# Rezoning Transportation Analysis

Petition Number: 2018-087

**From:** Felix Obregon, PE  
[fobregon@charlottenc.gov](mailto:fobregon@charlottenc.gov)  
704-432-5729

| Date     | Description  |
|----------|--------------|
| 08-14-18 | First Review |

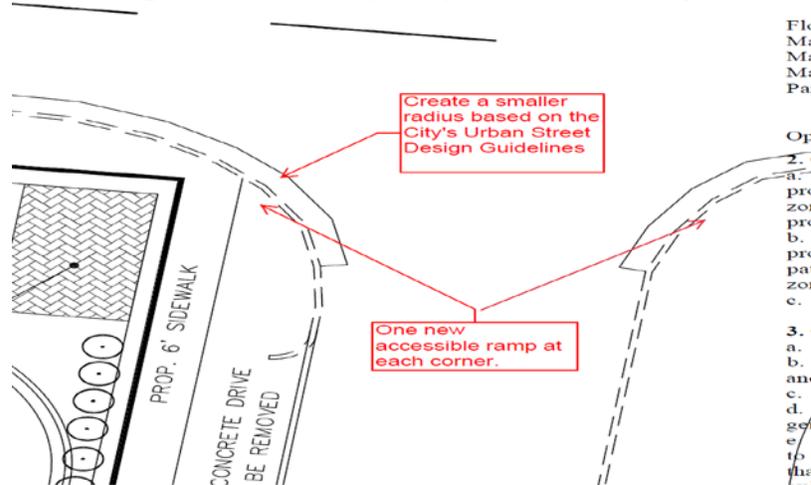
1. **Curbline** The proposed zoning district has a setback measured from back of the existing or proposed future curbline. The location of the future back of curb is in its current location.
2. **Traffic Study** A Traffic Impact Study/Transportation Technical Memorandum is not necessary for the complete review of this petition.
3. The petitioner should revise the site plan and conditional note(s) to construct 8' planting strip and 6' sidewalk along Central Avenue. (CDOT suggests petitioner angles the parking spaces more to create more space for planting strip and sidewalk)

4. The petitioner should revise the site plan and conditional note(s) to construct one ramp at each corner of Iris Drive and Central Avenue to improve pedestrian walkability.
- 5.
6. The petitioner should revise the site plan and conditional note(s) to construct a small radius based on the City's Urban Street Design Guidelines to improve pedestrian walkability.

7. The petitioner should revise the site plan and conditional note(s) to create a smaller curb radius on the corner at Iris and Central.
8. The petitioner should add a conditional note to state the Hardscape Amenity Area will not conflict with street sidewalks or accessible ramps.
